IMPORTANT CORRECTION OF DRUG INFORMATION

Subject: Fluzone (Influenza Vaccine) Syringe Label-Formatting Error in the 2-Dimensional Data Matrix Barcode Encoding Lot Number and Expiration Date

Figure 1. The label on each prefilled syringe of Fluzone® (Influenza Vaccine) contains a **2-D data matrix** (NDC + lot number + expiration embedded)

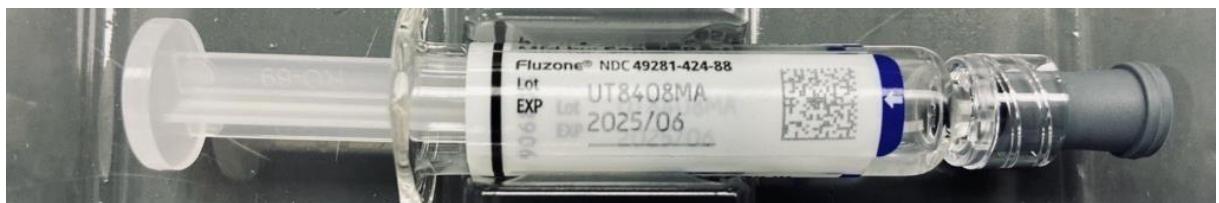
The 2-D data matrix barcode on the syringe (see Fig 1) is designed to be read by GS1 compliant scanners and encodes the NDC, product expiration date, and lot number. However, there is a formatting error affecting all doses from the listed lots, which prevents the data from being uploaded correctly. While the NDC, expiration date, and lot number are correct in the 2-D data matrix barcode, the order of the lot number and expiration date were reversed.

Below is an example of a syringe label with a 2-D data matrix barcode that will be uploaded incorrectly by electronic scanners. This image also shows the location of the printed NDC, lot number (Lot) and product expiration date (EXP).

Please see pages 3 through 8 of this letter for a list of the affected lots and a corrected 2-D data matrix barcode for each lot number. Each 2-D data matrix barcode is unique to a specific lot number. For customers who scan this information electronically, please use the corrected 2-D data matrix barcode on pages 3 through 8 of this letter. Please verify you are using the correct 2-D data matrix barcode for the lot number printed on each syringe (Fig 1). For customers who manually enter this information as printed on the syringe label, there is no change to the process.
